Access Compliance Report

Public Rights-of-Way

(Curb Ramps)

Intersection ID: 18963	Main Street: GROVER_RD	Cross Street: SOUTH_BV	Location: SE
ADA ID: 5F679A3B2069	Ramp Type: Perp	Initial Pass/Fail: Fail	Overall Compliance: No
Severity Score: 12.5			
Codes/Mitigation Info/Possible Solution		Field Measurements/Component Compliance

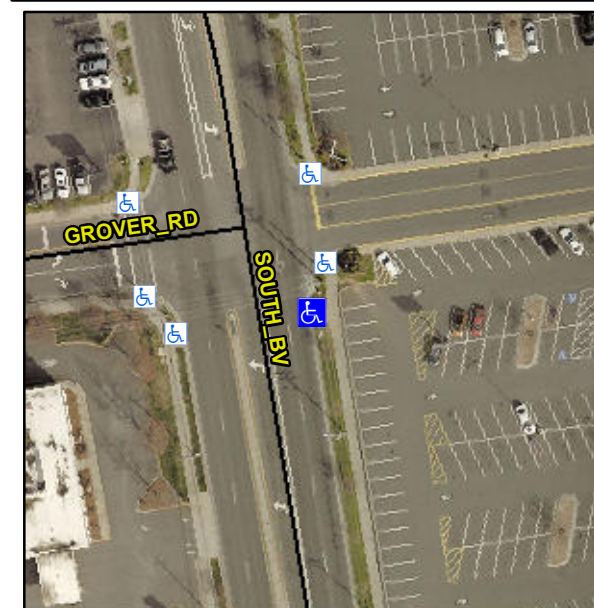
Not Found, R304.2.2

Compliance	Description	Data	Compliance	Description	Data
N/A	Ramp Length (in)	92.0	No	Ramp Slope (%)	9.2
Yes	Ramp Width (in)	96.0	Yes	Ramp XSlope (%)	1.7
N/A	Flare Type LT	N/A	N/A	Flare Type RT	N/A
N/A	Flare Slope LT (%)	N/A	N/A	Flare Slope RT (%)	N/A
N/A	Flare Traversable LT?	N/A	N/A	Flare Traversable RT?	N/A
N/A	Landing Length (in)	N/A	N/A	DWS Provided?	N/A
N/A	Landing Width (in)	N/A	N/A	DWS Contrast?	N/A
N/A	Landing Slope (%)	N/A	N/A	DWS Length (in)	N/A
N/A	Landing X Slope (%)	N/A	N/A	DWS Full Width?	N/A
N/A	Landing Curb? (Y/N)	N/A	N/A	DWS Offset (in)	N/A
N/A	Shared Landing?	N/A			
N/A	Gutter Ponding?	N/A	N/A	Gutter Slope (%)	N/A
N/A	Gutter Lip Ht (in)	N/A	N/A	Gutter X Slope (%)	N/A
N/A	Painted X Walk1?	No	N/A	Painted X Walk2?	N/A
	X Walk 1 Direction	To W		X Walk 2 Direction	N/A
N/A	X Walk 1 Width (in)	N/A	N/A	X Walk 2 Width (in)	N/A
	X Walk 1 Slope (%)	0.0		X Walk 2 Slope (%)	N/A
	X Walk 1 X Slope (%)	4.5		X Walk 2 X Slope (%)	N/A

Remove & Replace Entire Ramp.
